FINISHED BLADES

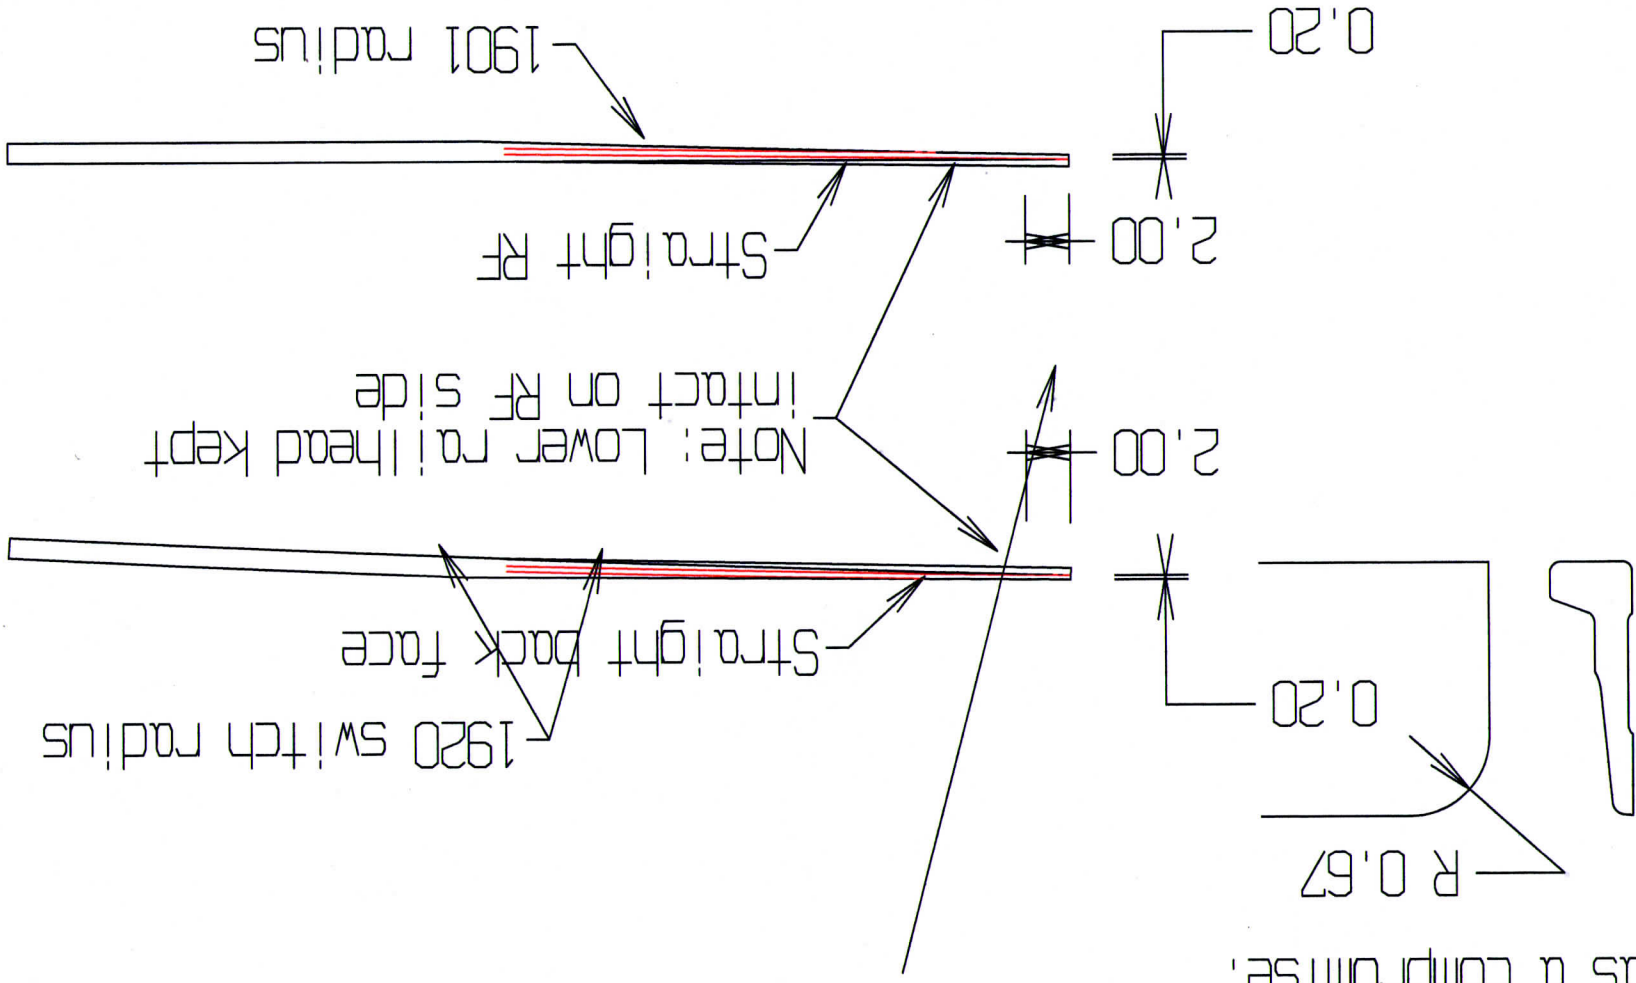
Thinning the running face (RF) to back face
 down to 0.2mm, gets to be quite difficult.
 If needs be then thin the last 2.0mm down to 0.2mm
 as a compromise.
